#### crane cove park schematic design

DRB + WDAC presentation

July 14, 2014

#### **DRB/ WDAC PUBLIC COMMENTS** (ON MAY 5TH, 2014 PLAN)

#### NORTHERN SHORELINE AREA

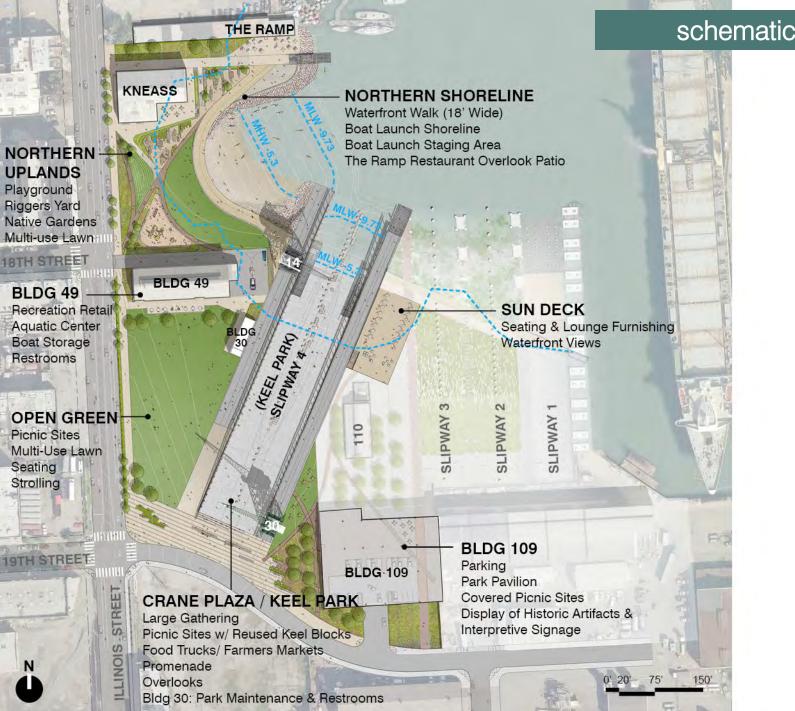
- Playground Expressed concern about 1. how the formal playground could negatively impact the redevelopment of the Kneass Building because of its close proximity and possible view blockage to the launch and Bay. Expressed concern with how the playground may interfere with the promenade circulation, and requested that other locations and other playground options be explored;
- Expressed concern about the height of the 2 berm adjacent to Illinois Street blocking views into the site.
- 3. Expressed concern about the amount of native garden planting area
